Access Compliance Report Public Rights-of-Way (Pedestrian Signals)

Main Street: AIROSO_ST Cross Street: CHIQUITA_CANYON_DR Location: SW

ADA ID: SGRK211130125239 Signal Type: One Push Button-Non APS Overall Compliance: No Severity Scores: BTN 1: 35 BTN 2: N/A No BTN: N/A

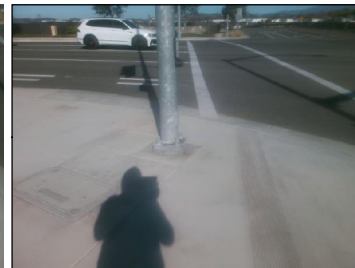
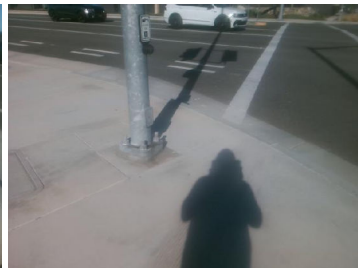
OC Std/PROW: R404.2, R404.3, MUTCD 4e.08

Possible Solutions: Replace Signal Push Button With APS Button. Remove and Replace Clear Space.
